The City of Miami's Amended Comments on the Draft Environmental Impact Statement

Combined Licenses for Turkey Point Nuclear Plant Units 6 & 7

RE: NUREG-2176 – City of Miami’s Amended Comments on Draft Environmental Impact Statement for Combined Licenses (COLs) for Turkey Point Nuclear Plant Units 6 & 7 (NRC-2009-0337)

Figure 2. Hydraulic Conductivity of the FPL Biscayne aquifer model.

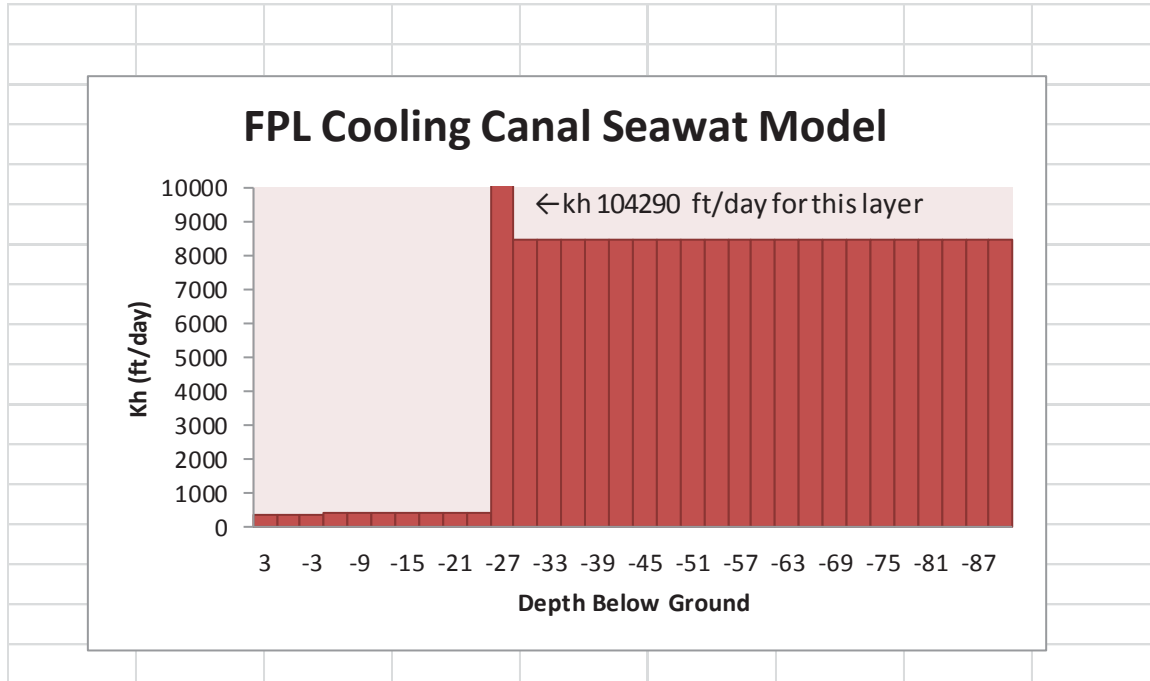
The use of a constant thickness and constant hydraulic conductivity for each layer of a model that stretches 136,000 feet across the Biscayne aquifer is a highly simplified representation of the groundwater system. FPL states that “No attempt was made to approximate the thinning of the aquifer to the west as it was believed that thickness changes would have an insignificant effect on model transmissivity given variability in hydraulic conductivity”. This simplifying assumption of constant aquifer thickness over the model domain is incorrect and may influence the advective flow component of the model and the associated movement of saline water within the aquifer. The assumption that the hydraulic conductivity does not change across the model and that the highly transmissive zone of the Key Largo Limestone is laterally contiguous at -27 feet NGVD is also questionable. Modification of the model to more accurately reflect the area hydrogeology would require the model to be recalibrated.

Figure 7. Simulated and observed water quality concentrations for well G-21 Deep.

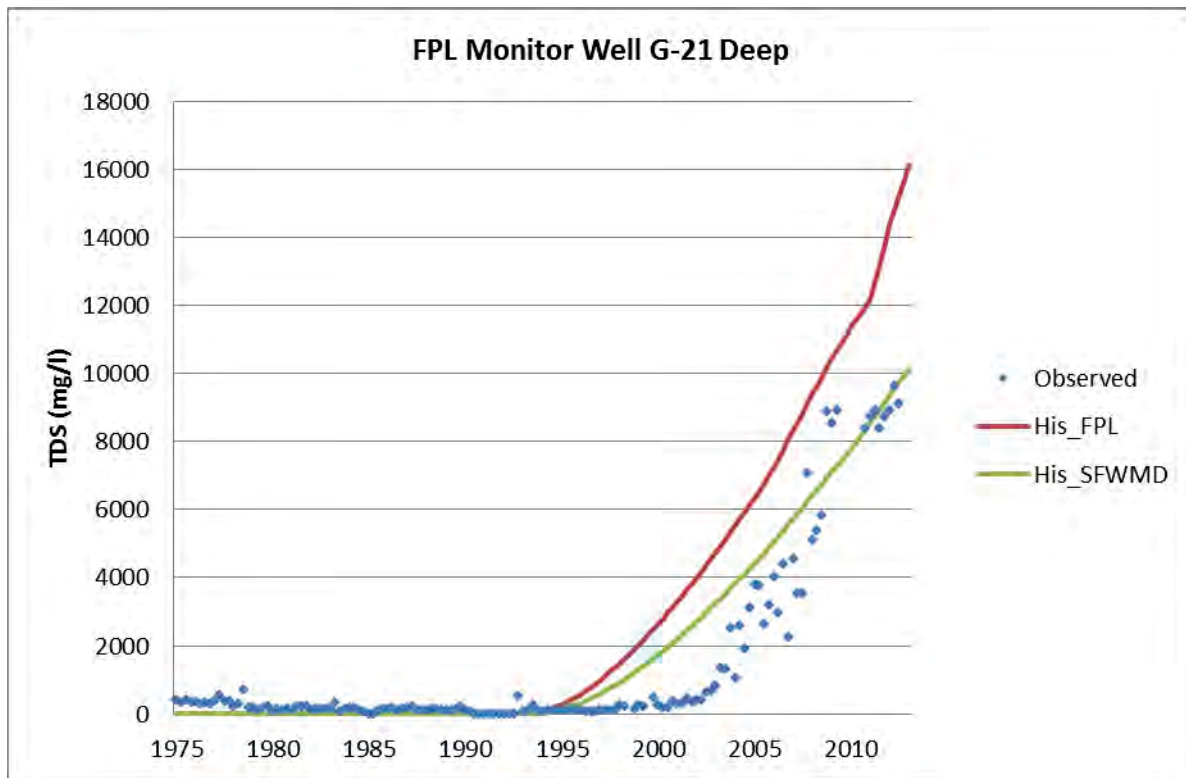
While the FPL report does compare historic salinity monitoring data to the model-calculated response, there is no information to describe whether the model reasonably represents groundwater stage and gradients. Comparison of groundwater stage data using monitoring data from wells located along the model transect to model-calculated stage data would provide valuable insights into the reasonableness of the models result in representing area hydrology. District staff included this analysis and water levels at well G-21 are shown in **Figure 9**. The observed and simulated water levels are significantly different, with both simulations having water levels approximately 1.0 feet higher than the observed values. This demonstrates the limitations of both models because they do not reflect changes in local hydrology included drainage canals, groundwater withdrawals, rainfall and other factors.

Figure 9. Water levels at well G-21.

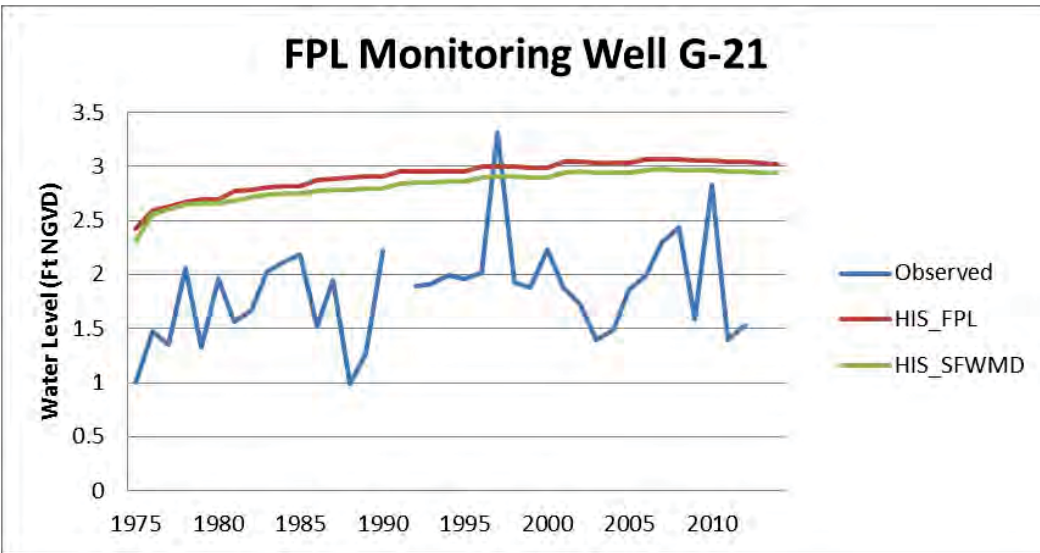
To further illustrate this issue with the model's inability to accurately simulate water levels in the western 1/3 of the model, water levels obtained from the SFWMD South Dade Model' which is a subset of the Lower East Coast Subregional (LECSR) Model (Giddings et. al., 2006), were plotted along the model transect and compared against the results from both the **HIS_FPL** and **HIS_SFWMD** simulations. The LECSR model is a highly calibrated model and includes all hydrologic aspects of the system. It is simulated on a daily basis and the results presented here are the average water levels from 1985 through 2000 for the calibration period. **Figure 10** provides the comparison between models.

Figure 10. Water levels along the model transect.

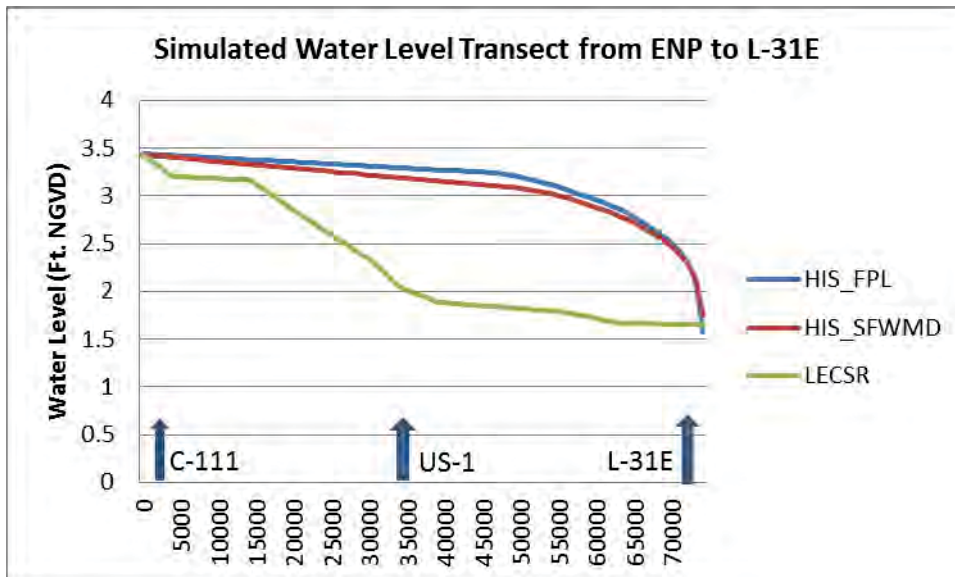
To correct the model to more accurately simulate observed water levels would require wholesale changes to the model parameters and incorporation of packages which simulate actual conditions (i.e.,

Figure 11. Sensitivity model run with observed water level conditions in south Miami-Dade County.

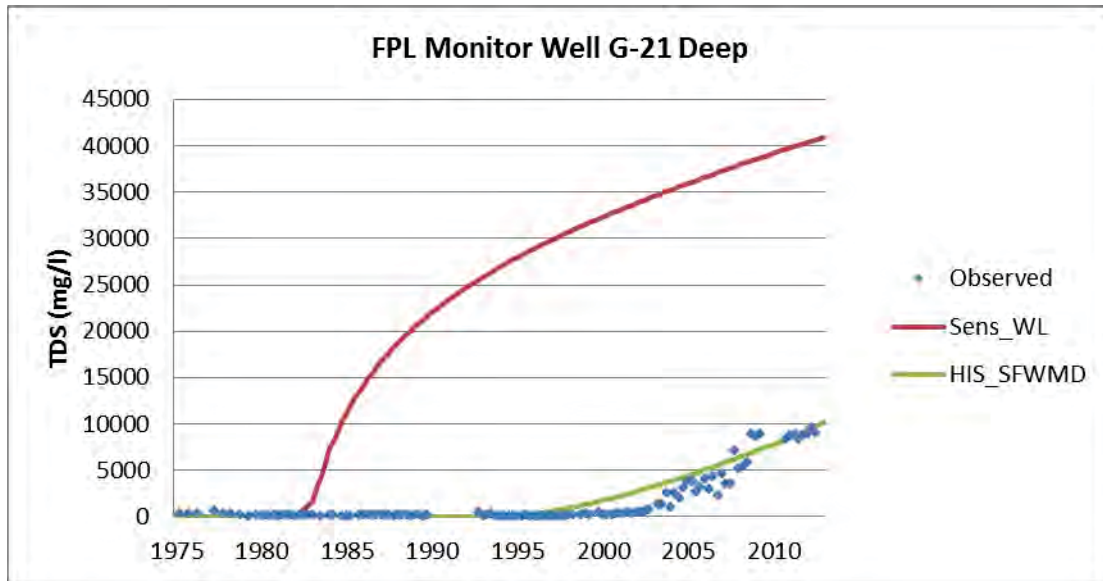
wellfields). **Figure 11** provides the results of concentrations at well G-21 Deep for a sensitivity run where water levels in the western portion of the model were reduced 1.0 feet to represent more realistic water level conditions in the south Miami-Dade agricultural region. As shown in **Figure 11**, the salt water interface becomes highly unstable and suggests that the interface should have passed well G-21 Deep many years before actually being observed. This illustrates the limitations of the 2-D model and would require additional calibration and possibly a full 3-dimensional model to accurately simulate conditions in southern Miami-Dade County.

Figure 14. Location of the 10,000 mg/l TDS line at the base of the Biscayne aquifer for the FPL simulations.

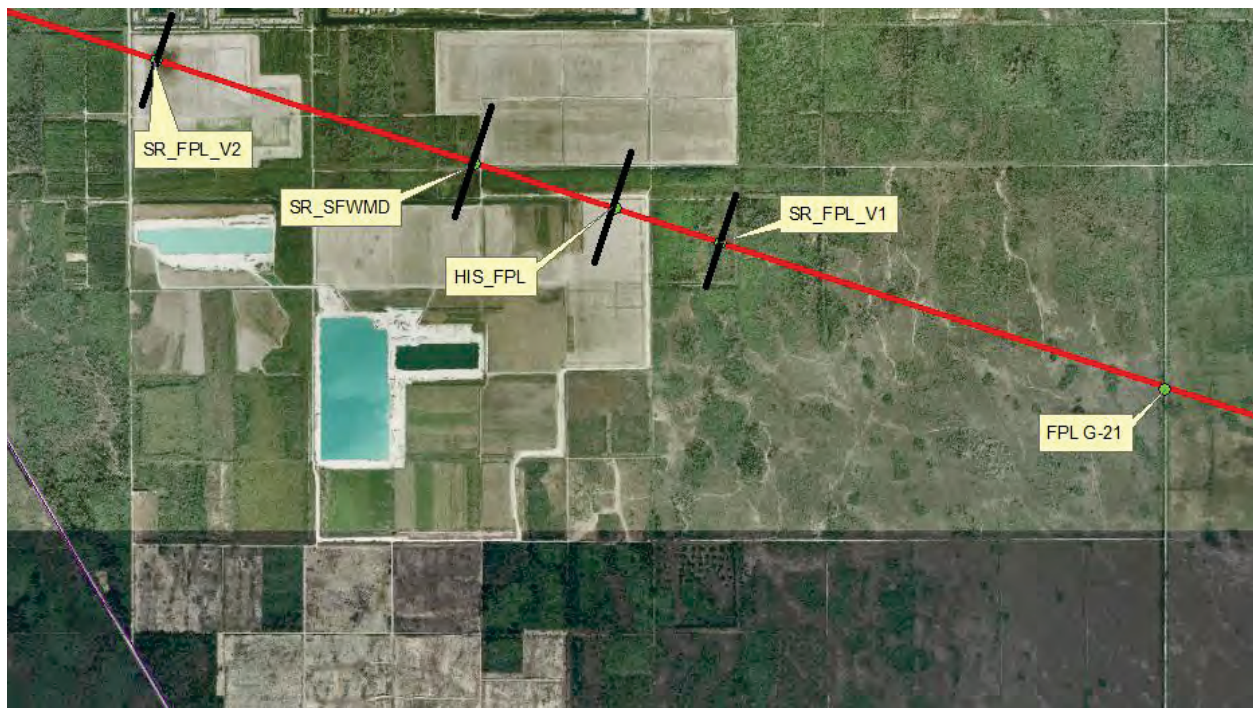
Figure 14 provides the estimated location of the 10,000 mg/l TDS interface at the base of the Biscayne aquifer for the three FPL simulations. In the documentation provided by FPL, it was concluded that the salt water interface would move eastward as a result of the proposed addition of 14 mgd of

fresh/brackish water to the CCS. This is shown by comparing the position of the **HIS_FPL** and **SR_FPL_V1** lines. The position of the **SR_FPL_V1** has the incorrect head for the western boundary which gives an inaccurate conclusion. Correcting the head on the western boundary actually results in a westward movement of the interface even with the salinity reduction proposal as shown by the position of the interface at point **SR_FPL_V2**. Also note that the position of the interface as predicted by the **SR_SFWMD** run is eastward of the **SR_FPL_V2** run.

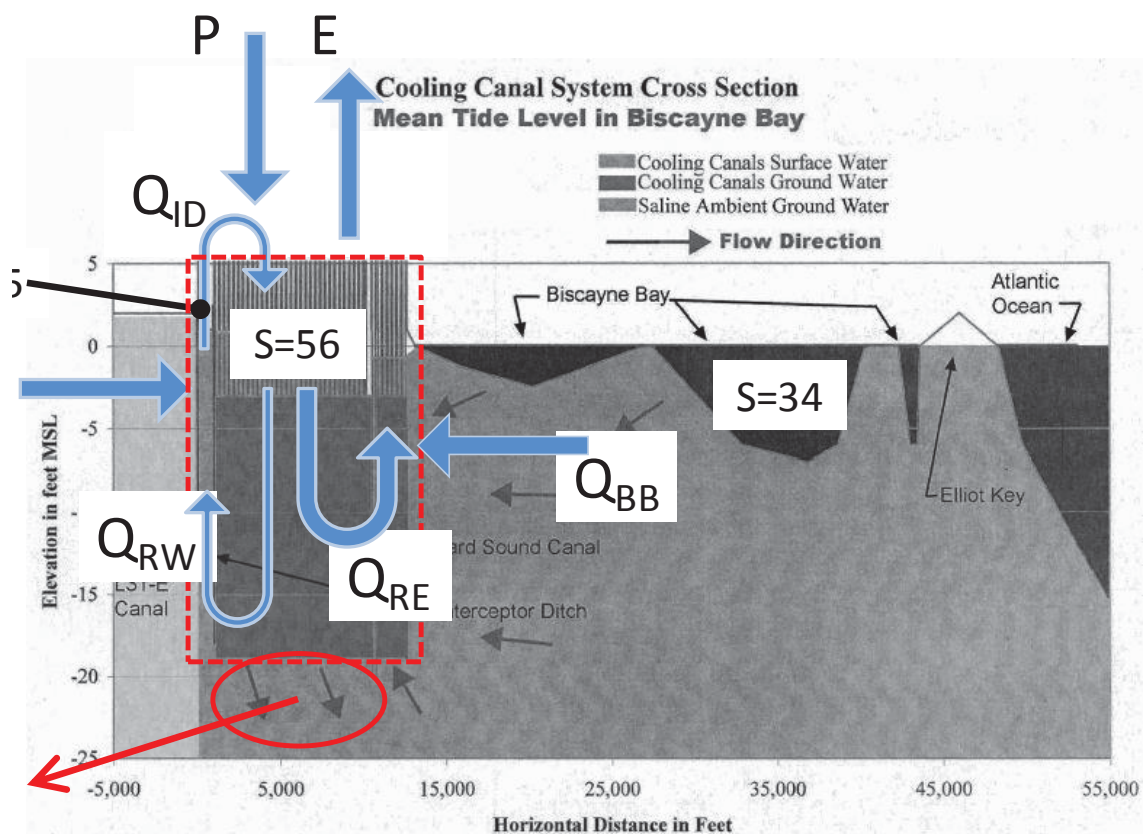
I verified the 14 mgd figure by altering the long-term water budget calculations, described in my 5 April 2013 report, to take account of this new input. My approach uses a control volume similar to the control volume used in the analysis by Golder Associates¹, Figure 1. The inputs and outputs to this control volume are evaporation Q_E , rainfall Q_R , seepage of Biscayne Bay water Q_{BB} , net seepage to/from the aquifer Q_L , and seepage of fresh groundwater into the interceptor ditch Q_F . The measured water flux due to interceptor ditch pumping Q_{ID} is internal to the control volume, but it is used in the analysis to estimate Q_F . The results of the FPL water budget reported in the 2012 annual report² indicate that plant blowdown does not contribute significantly to either the water or salt balance, so its value is assumed to be zero for purposes of the following analysis.
